**RE: Stone Age Climbing Gym
6200 Alameda NE
Grading & Drainage Plan and Drainage Report
Engineer's Stamp Date: 09/05/19
Hydrology File: C18D086A**

**Drainage Report
For**

**Alameda & San Pedro Mixed Use
Stone Age Climbing Gym**

**RE: Stone Age Climbing Gym
6200 Alameda NE
Grading & Drainage Plan and Drainage Report
Engineer's Stamp Date: 08/19/19
Hydrology File: C18D086A**

1 | grading and drainage plan

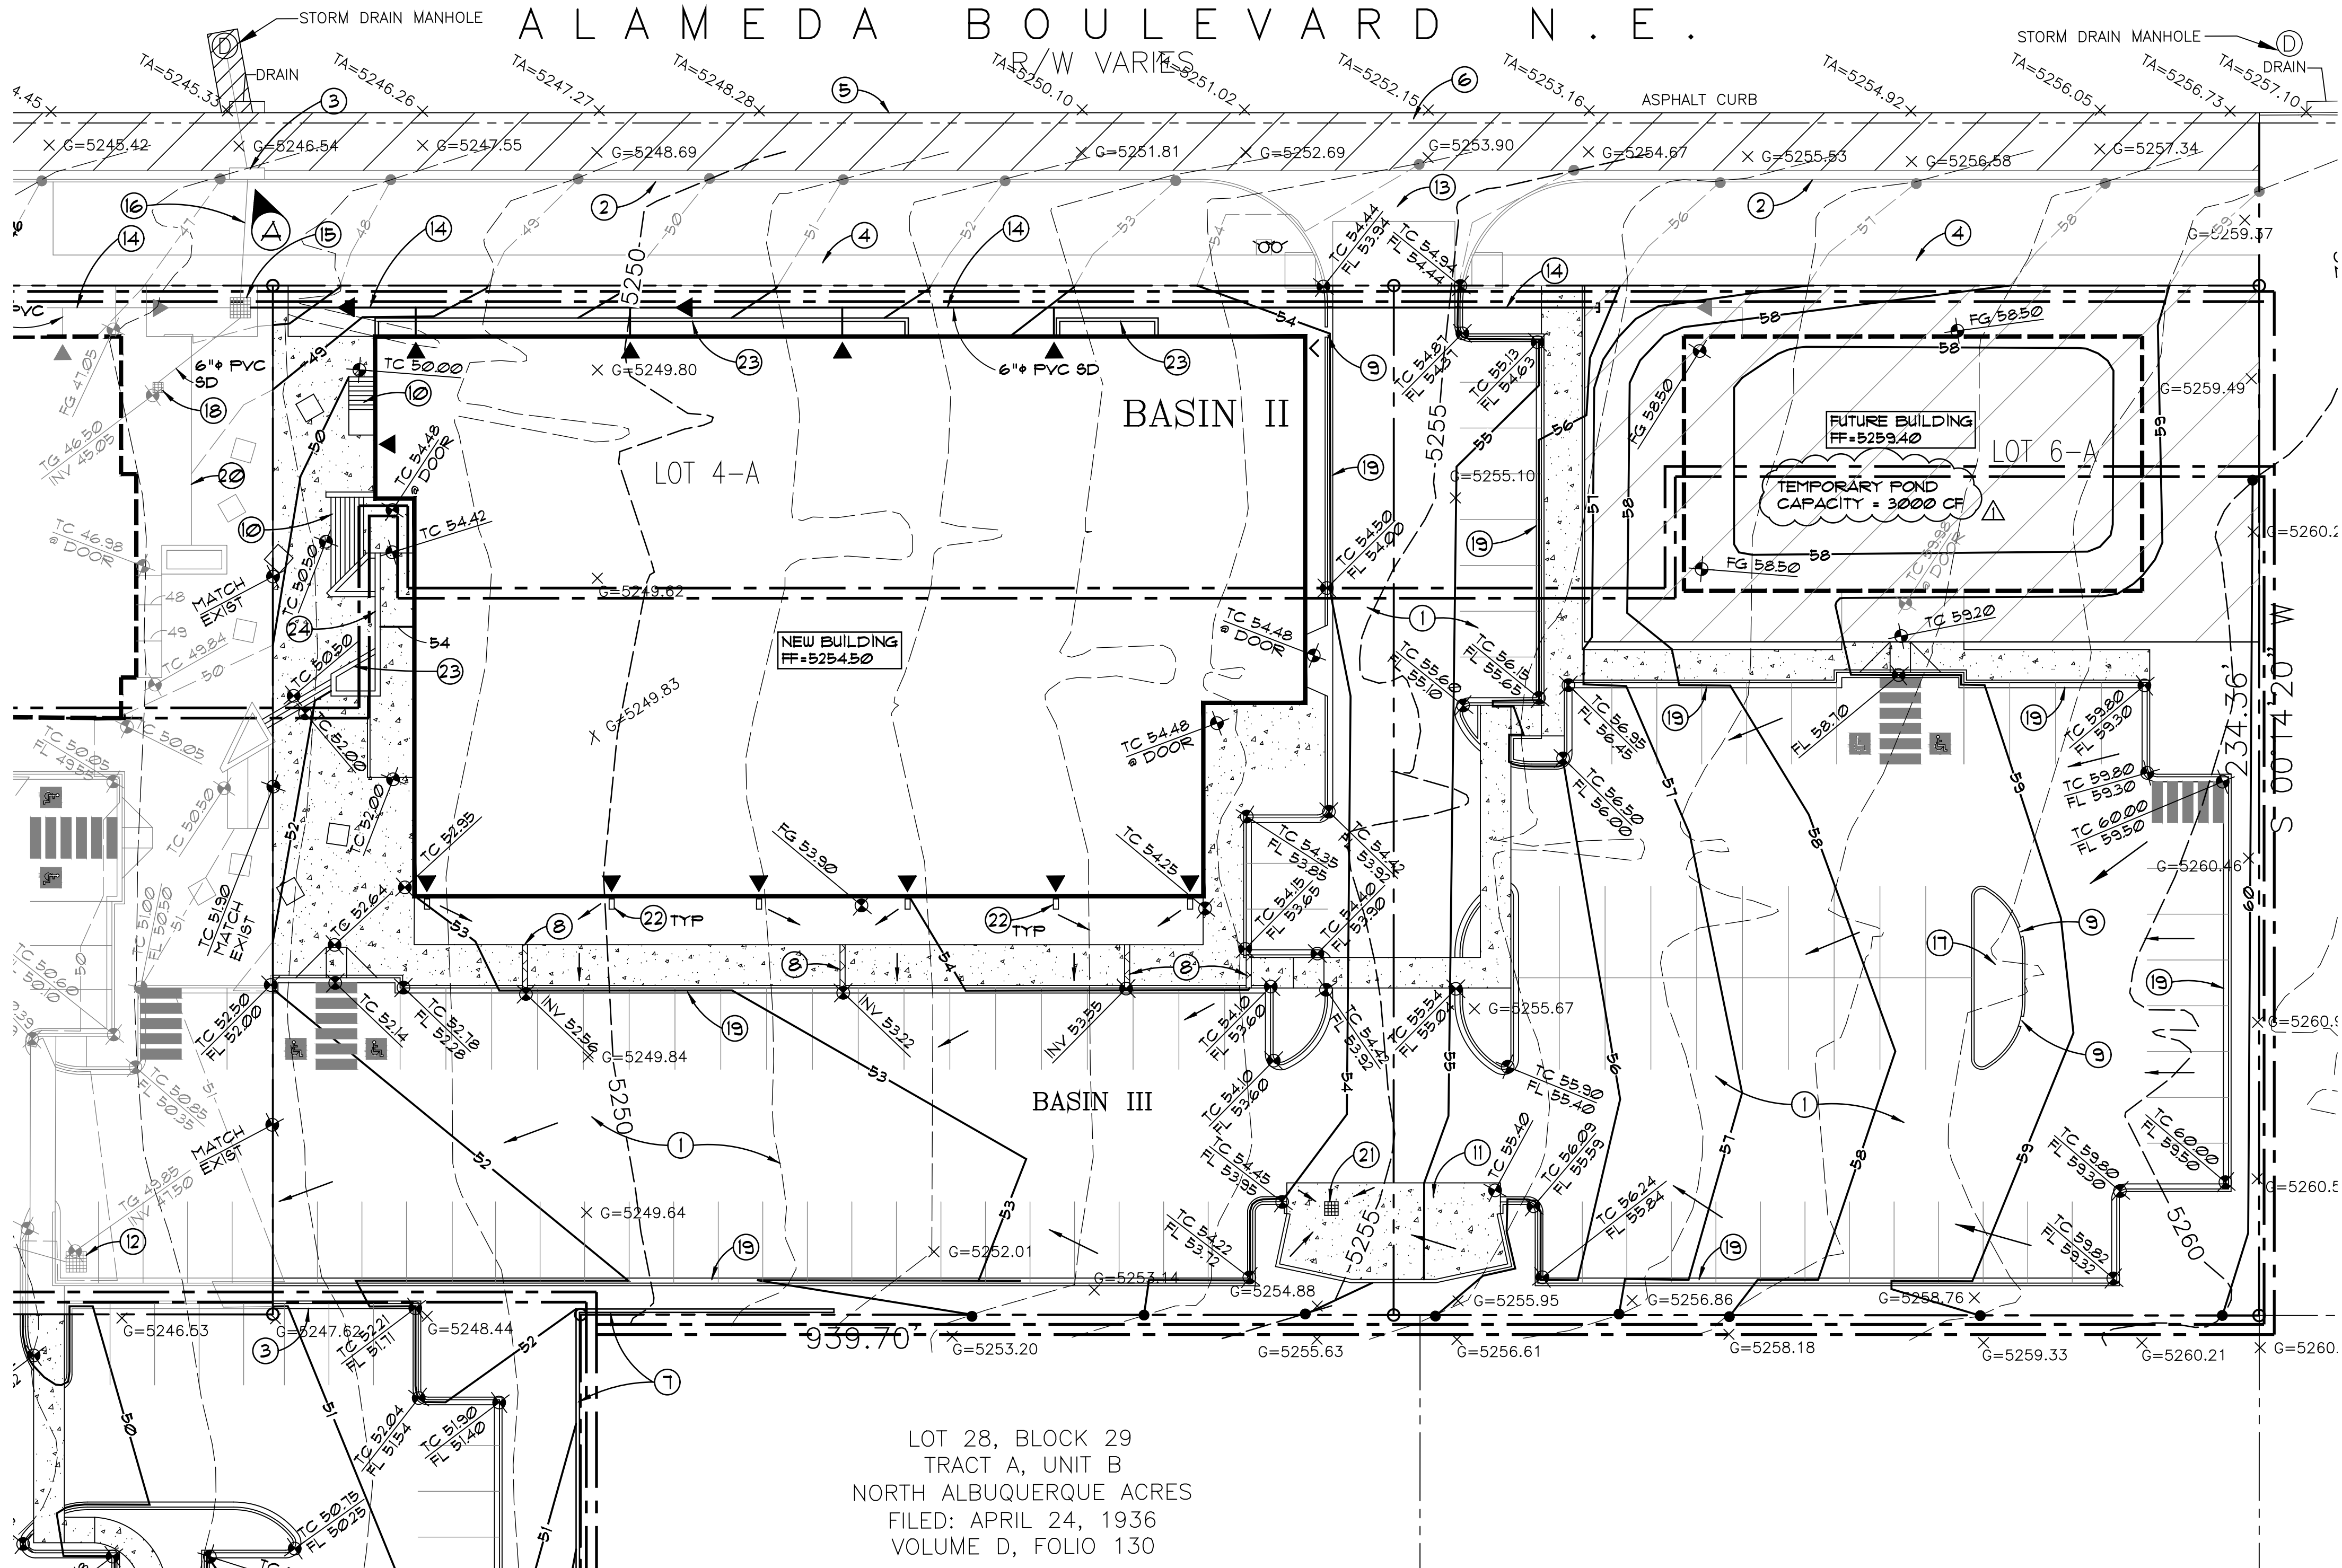
1. Grading & Drainage Plans. There is a temporary retention pond at the area of a future building near the northeast corner of the development. I do not see any purpose for the retention pond. There will be no drainage going into this pond. This area should just be graded for the future pad of the building.

2. Grading & Drainage Plan. Under the Drainage Points, "C" should be 4.02 cfs. This will match the drainage for Basin I in the Ultimate Development.
3. Grading & Drainage Plan. The proposed grate in Basin I is too high and needs to be at the southwest corner of the parking lot. This location is where all the drainage from Basin I is flowing towards. By leaving the inlet as shown, there will be pool of water collecting at the southwest corner of the parking lot. Please fix.

1. While we do not have a great deal of runoff directed toward the future building pad site on Lot 6-A there will still be some flow developed on this site and so the pond has been reduced but will stay to prevent erosion to Alameda Blvd.

2. Drainage Point 'C' was incorrectly noted and has been corrected to 4.02 cfs.
3. The Basin I grate has a top of grate elevation approximately 1.25 feet lower than the high point of the water block in the drive access to Signal. This was done to provide a small amount of ponding in that corner of the parking lot should the runoff directed that way momentarily overtax the catch basin and grate, or the storm drain outlet to the Signal Ave. storm drain.
